ALERT SERVICE BULLETIN

REVISION NOTICE

SUBJECT: REVISION "B" TO ALERT SERVICE BULLETIN 212-00-106: (MAIN ROTOR MAST 204-011-450-007/-105/-113/-119 INSPECTION AND RETIREMENT INDEX NUMBER RIN REDUCTION)

SUBJECT: MAIN ROTOR MAST, P/N 204-011-450-007/ -105/ -113/ -119, INSPECTION AND RETIREMENT INDEX NUMBER (RIN) LIFE REDUCTION

Figure 1

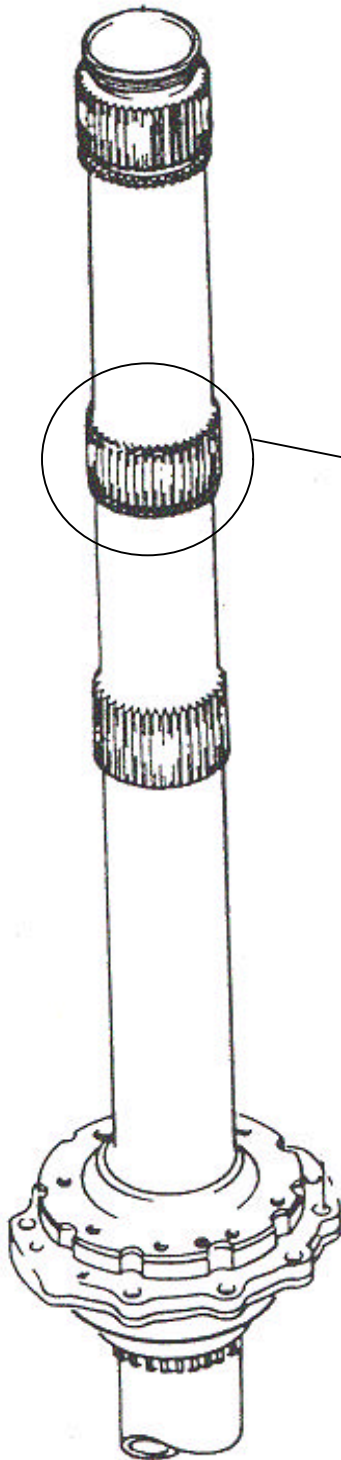
- 1. Inspect the mast snap ring upper and lower grooves (entire circumference) for a minimum radius of 0.020 (figure 2, and figure 3 view A-A). Any mast that has indications of a radius less than 0.020 shall apply a 165,000 RIN penalty to the mast.

Inspect area for:

- At 100X minimum magnification
Minimum radius of 0.020 in the
upper and lower snap ring groove,
entire circumference
- At 200X minimum magnification
Burr in the snap ring groove/spline
intersection, all places

Figure 2
Snap ring groove / spline intersection

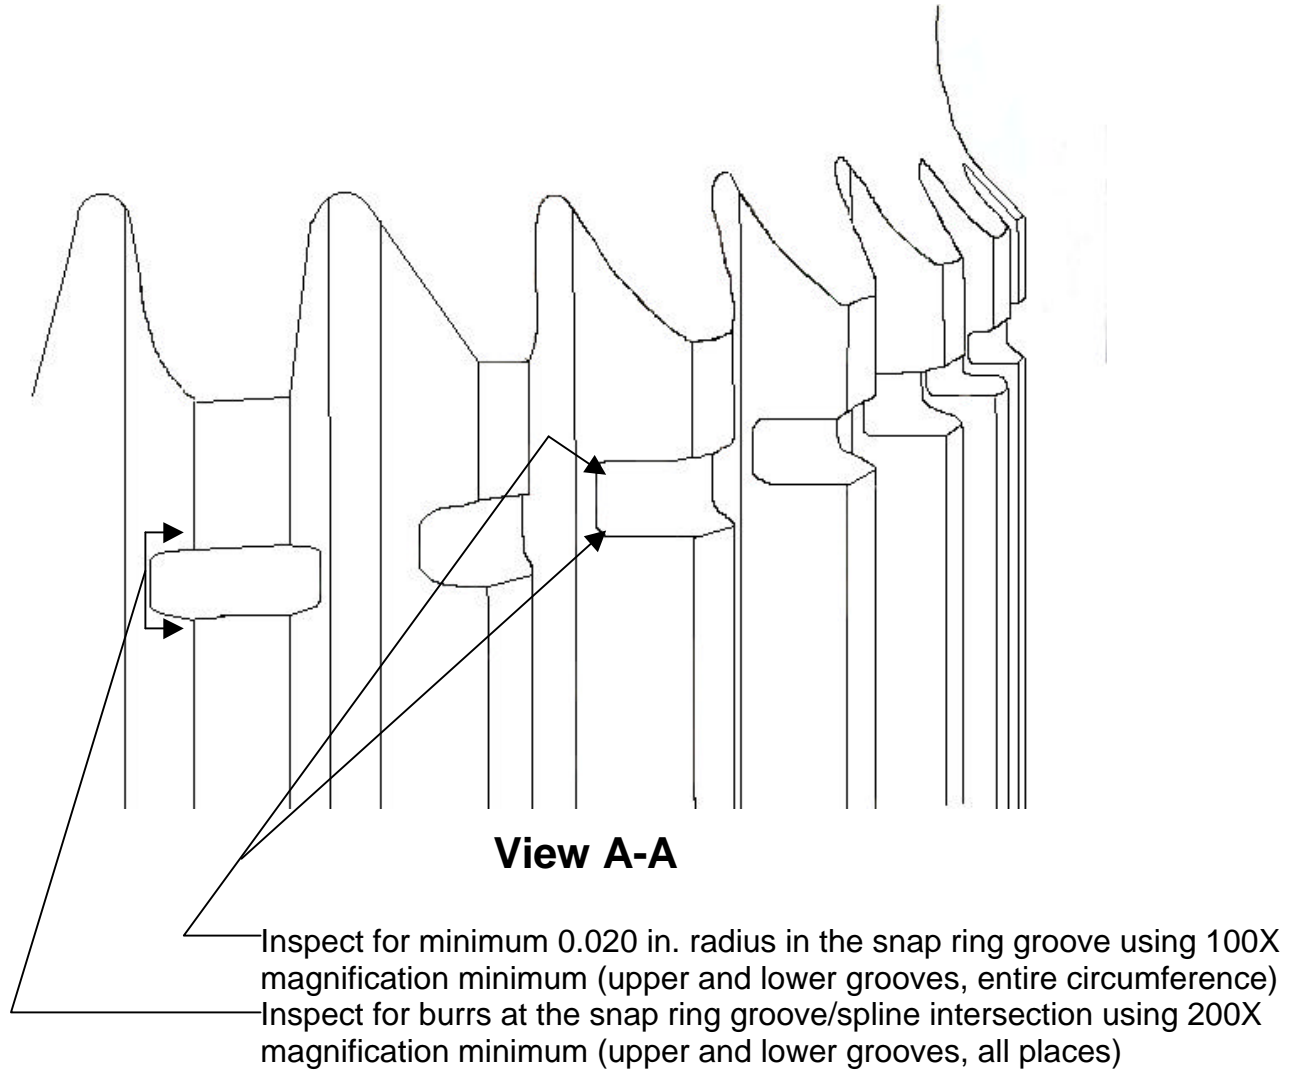
2. Inspect the mast snap ring upper and lower grooves for indications of burrs at all intersections with splines (see figure 3 view A-A, and figure 4). Any mast that has indications of a burr shall apply a 95,000 RIN penalty to the mast. Burr removal should not be accomplished.
3. Masts not exhibiting insufficient radius or burrs in the snap ring groove may continue in service until reaching the revised retirement of 265,000 RINs / 15,000 hours.
4. Annotate Historical Service Records showing compliance with this bulletin.

FIGURE 3
Typical Burr at Snap Ring Groove

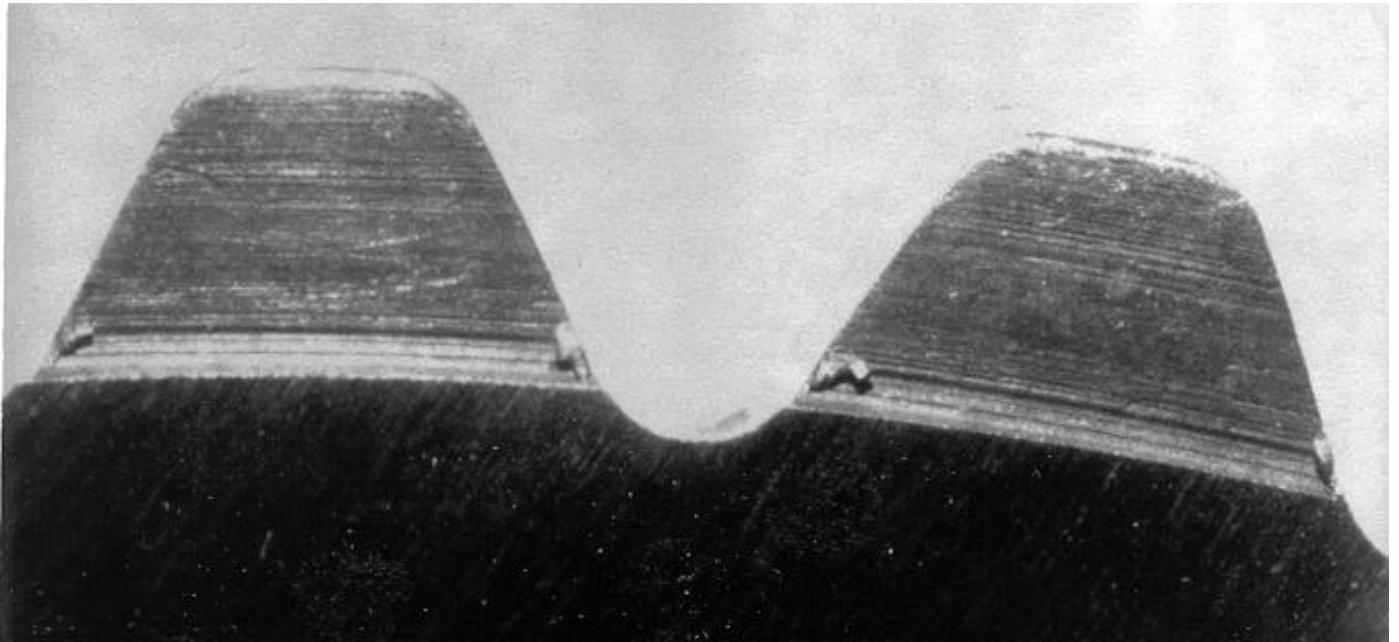
Cutaway View looking down from inside snap ring groove
Typical burrs at snap ring groove/spline intersection
Burrs are to be inspected at 200X minimum magnification
